TMCA SOUTH CENTRAL TOWER
LEVEL 03 REFRESH

ISSUE FOR CONSTRUCTION
VOLUME 1 OF 1

City of Aurora Building Division
Project: *Plan Revisions*
Address: *1501 S Potomac St*
Occupancy Group: *I2*
Construction Type: *IA-Spk*
RSN: *1777501*
Permit: *24-2410546-LT*

MARK	ISSUE	DATE
7	ADDENDUM #5	01.04.24
6	ADDENDUM #4	11.30.23
5	ADDENDUM #3	05.17.23
4	RFI 51	03.09.23
3	ADDENDUM #2	03.13.23
2	DFPC Revision #1	01.10.23
1	FGI REVIEW 1	09.16.22

MECHANICAL HVAC PLAN

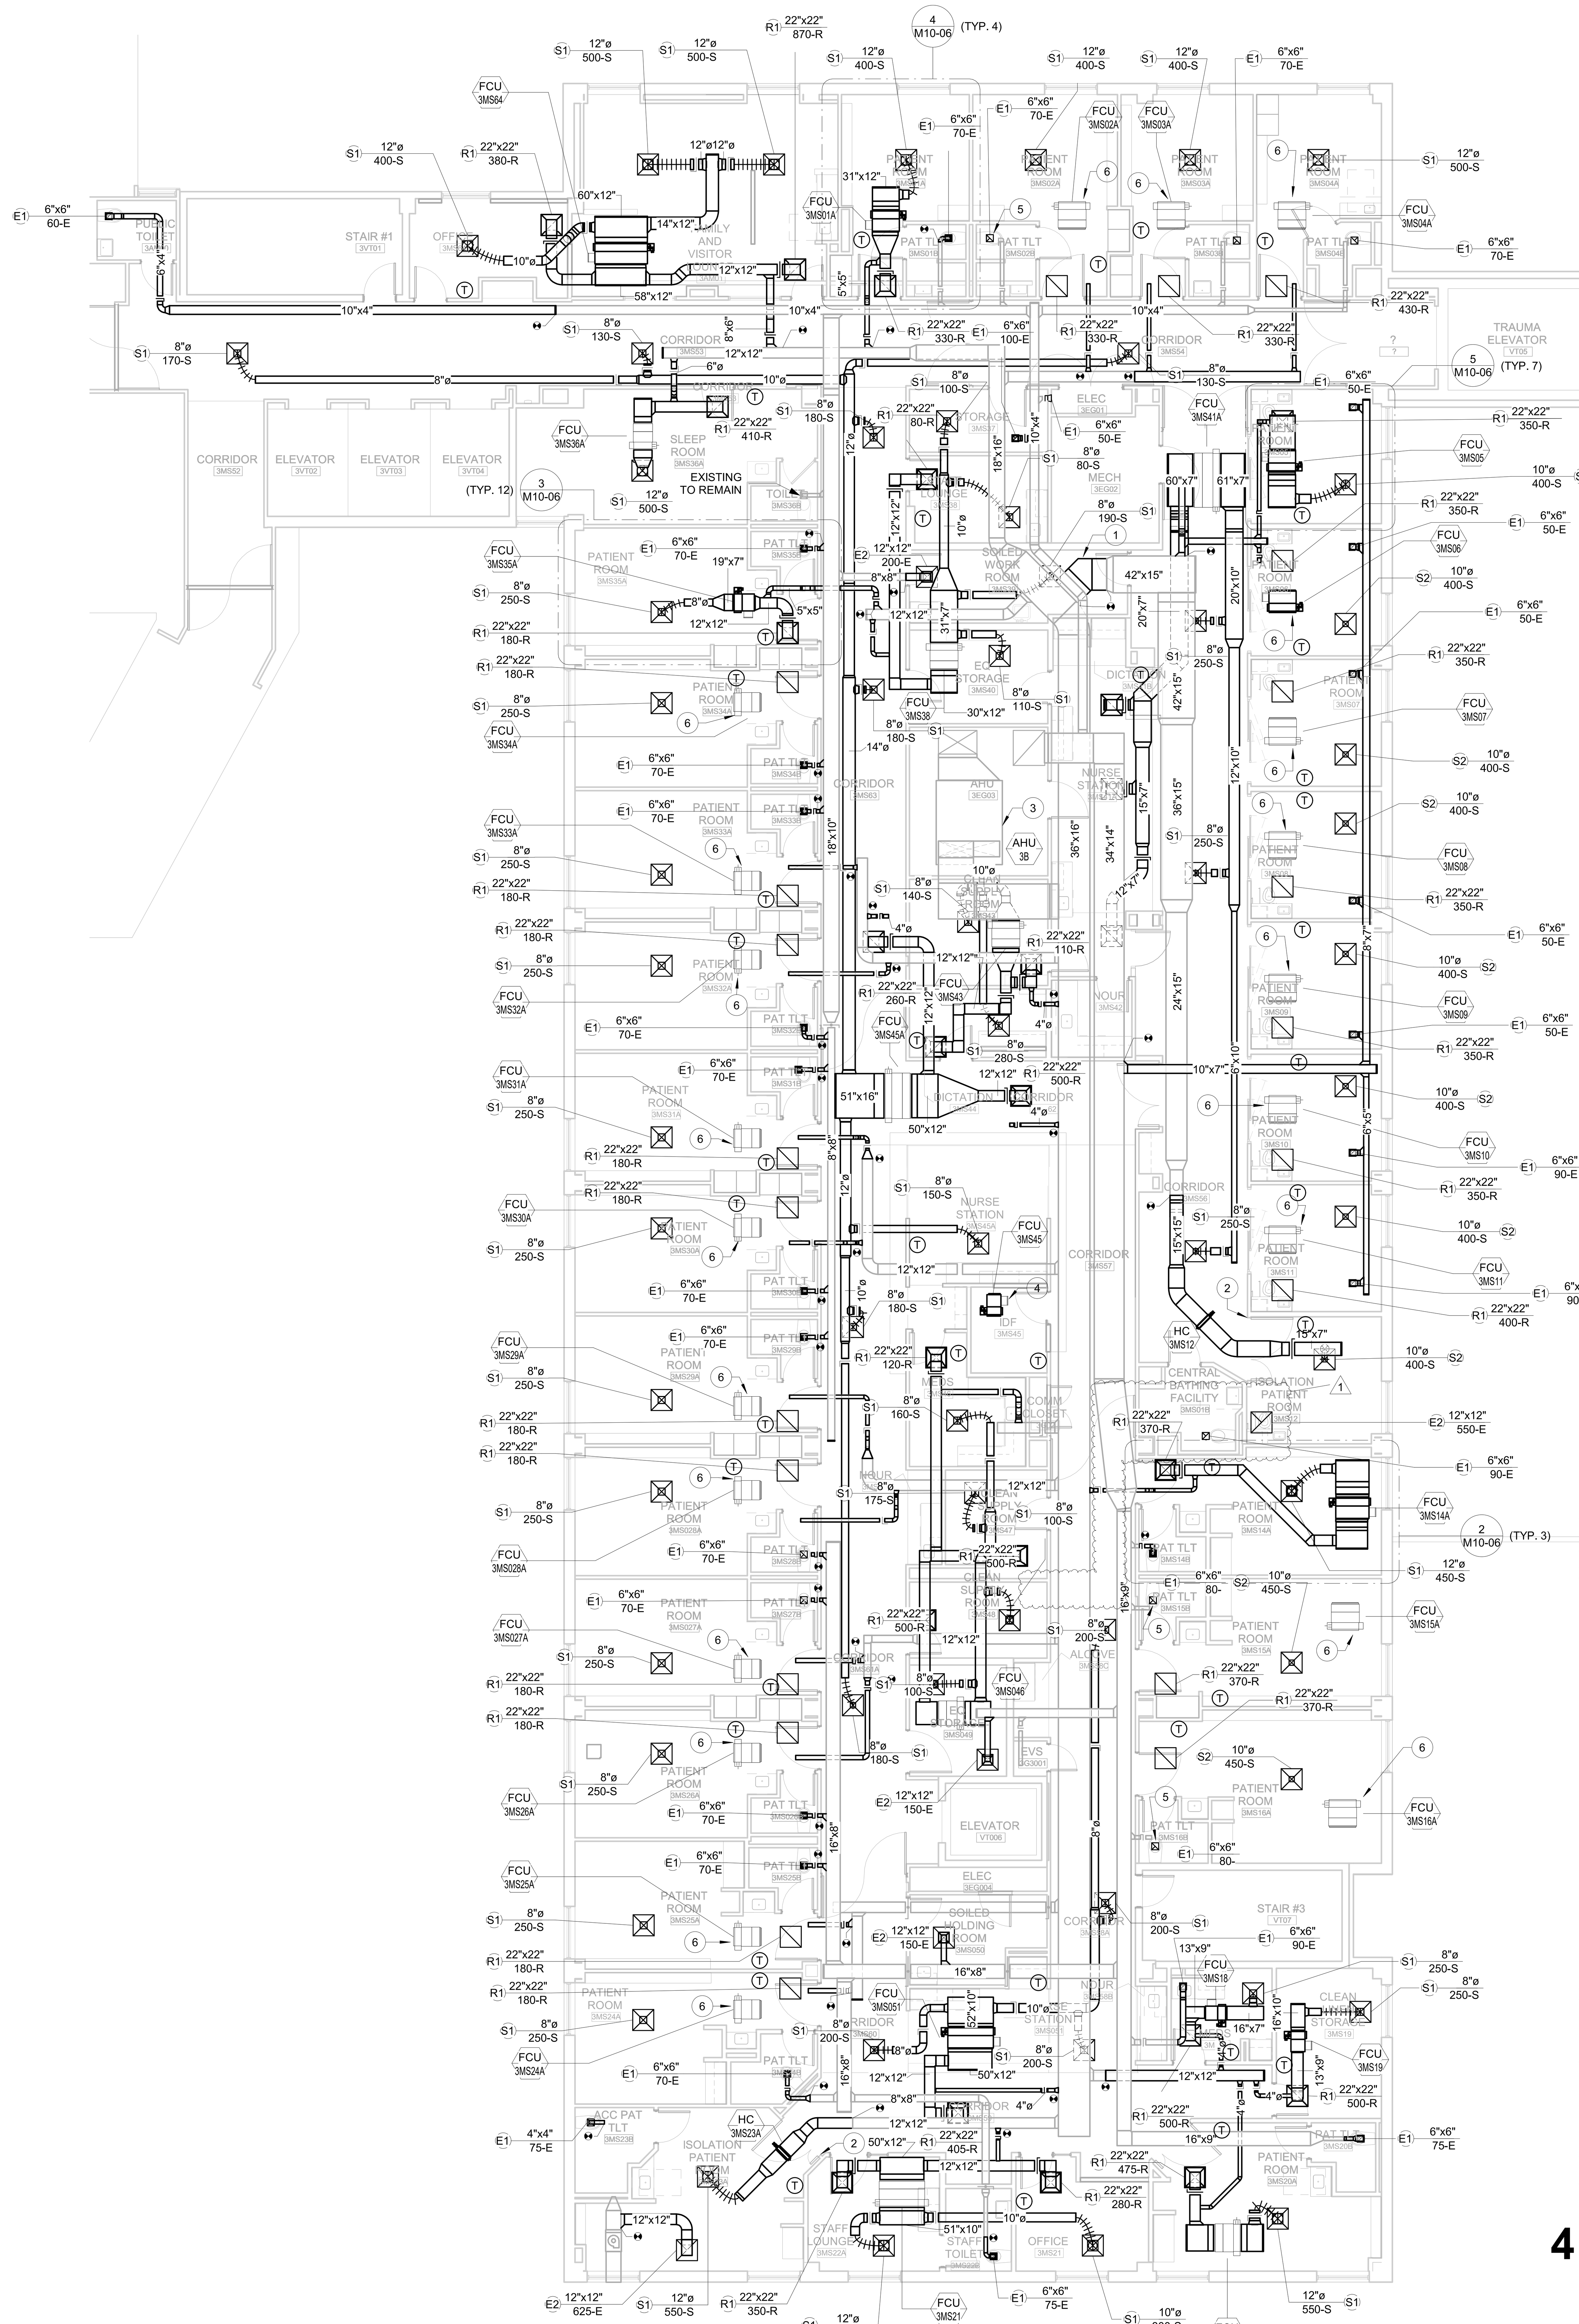
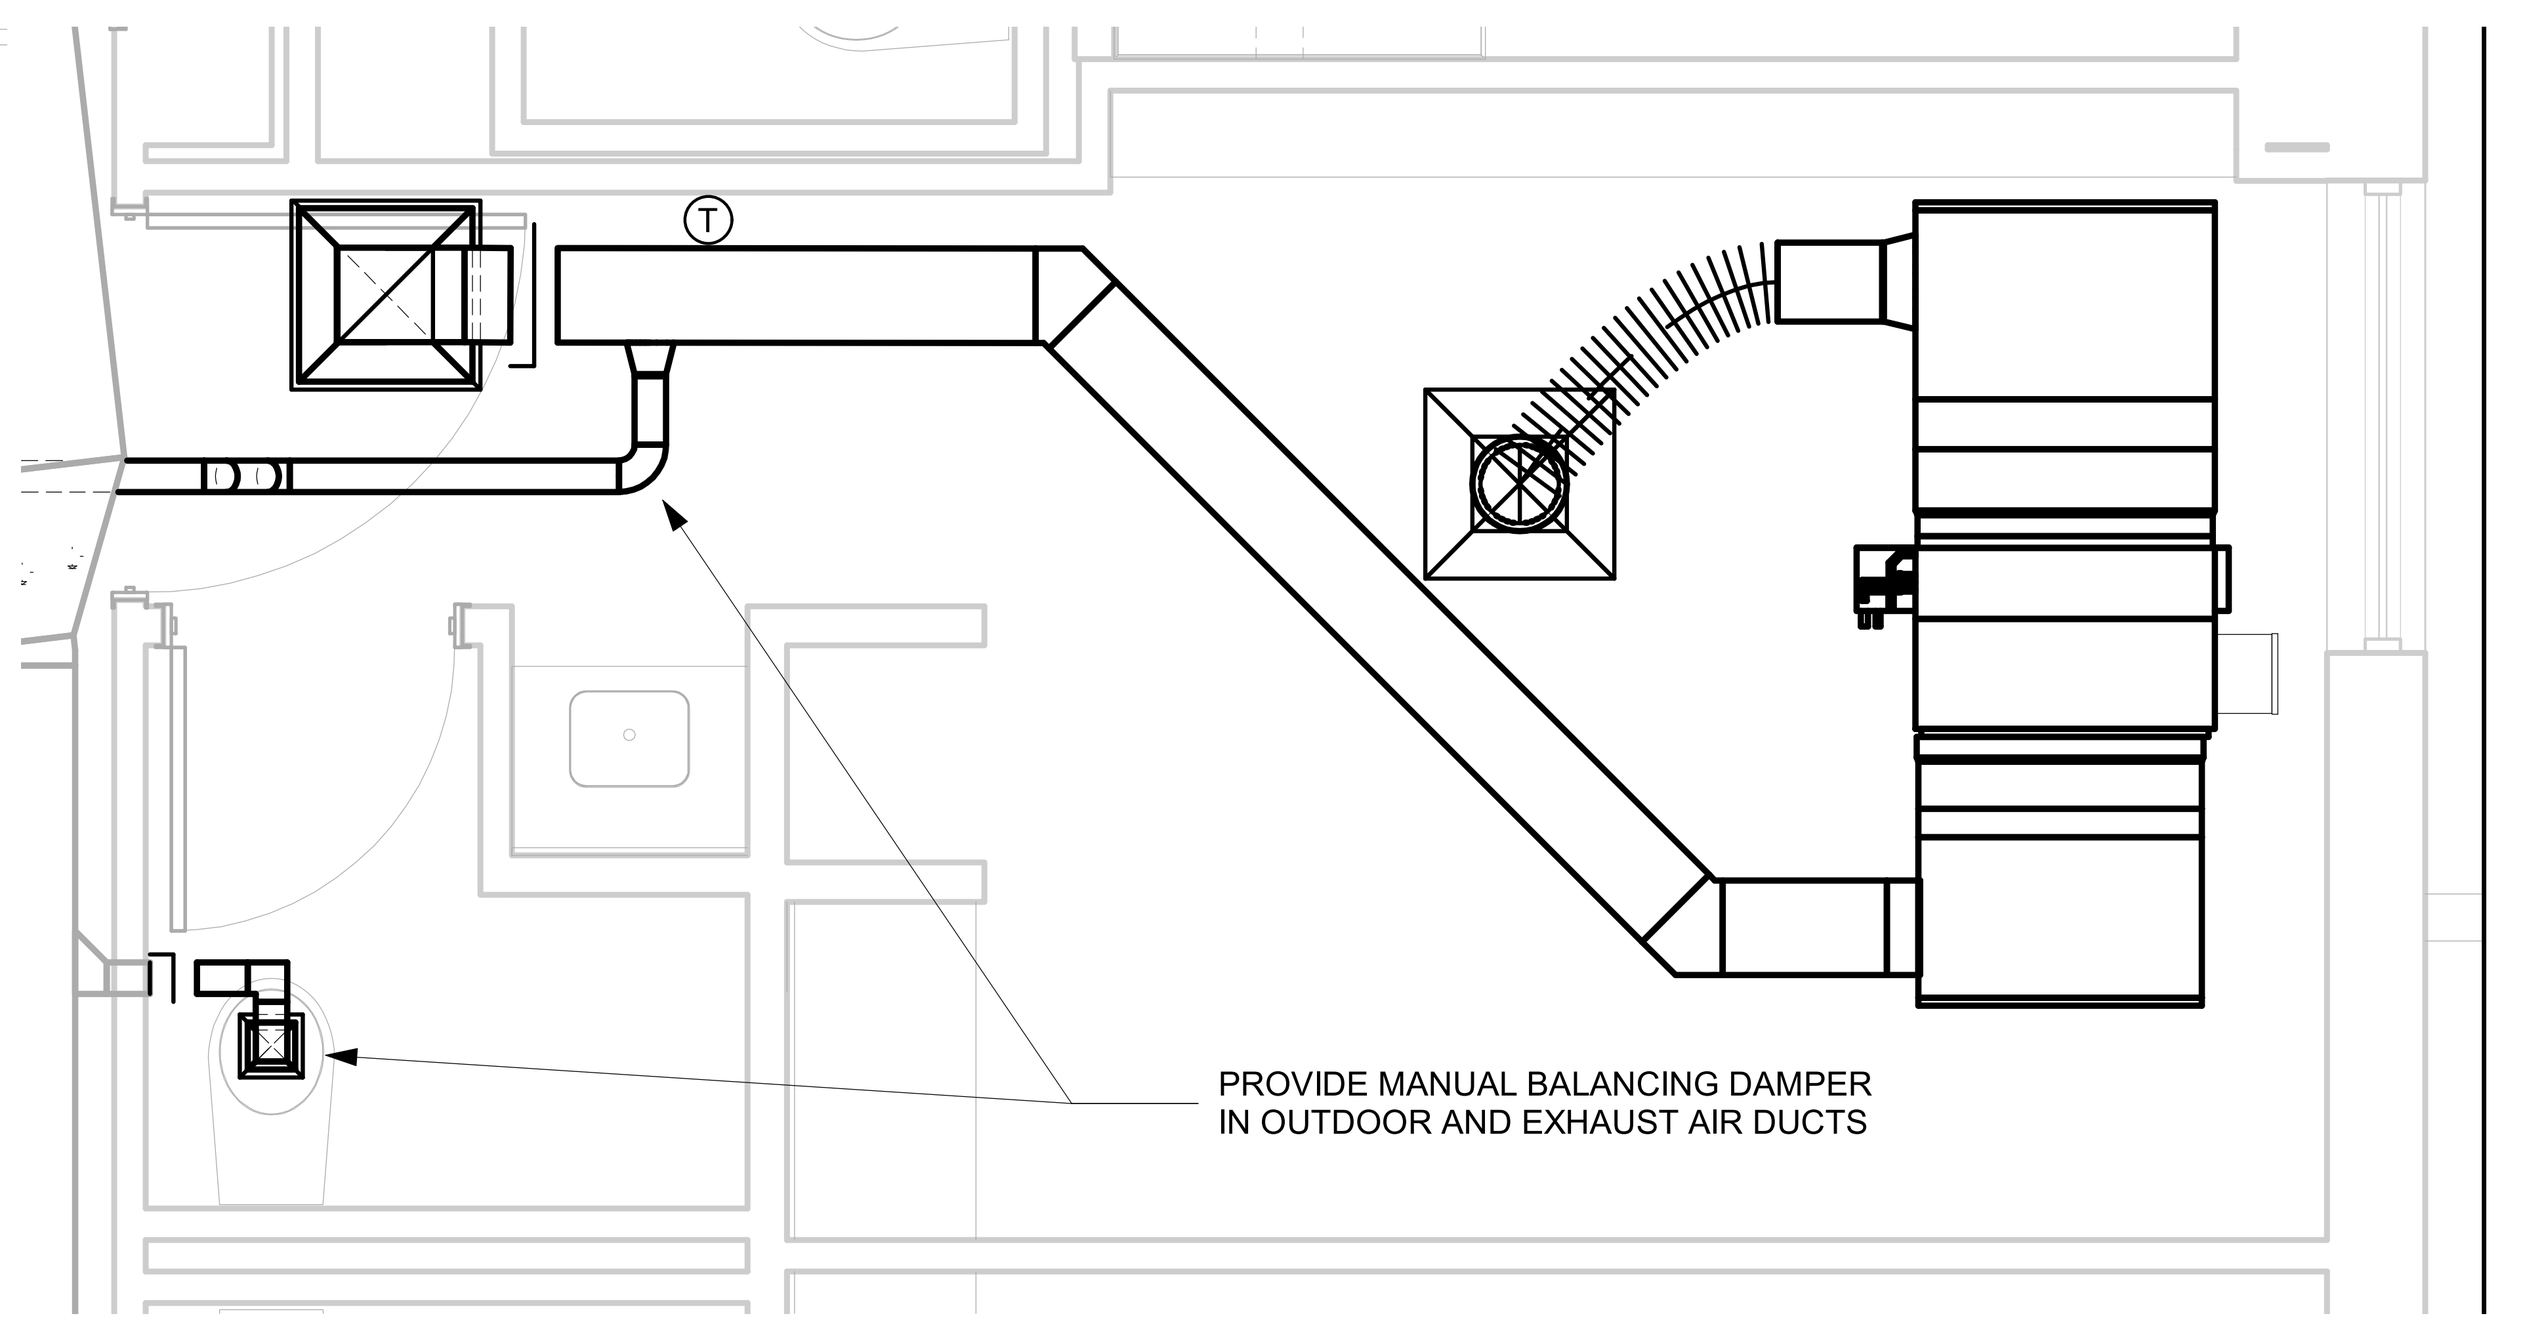
6. FAN COIL UNITS SHALL BE FULLY DUCTED TO SUPPLY AND RETURN GRD'S ~~WITH OUTDOOR AIR CONNECTED TO RETURN DUCT AS SHOWN.~~
7. REMOVED IN ADDENDUM #5.
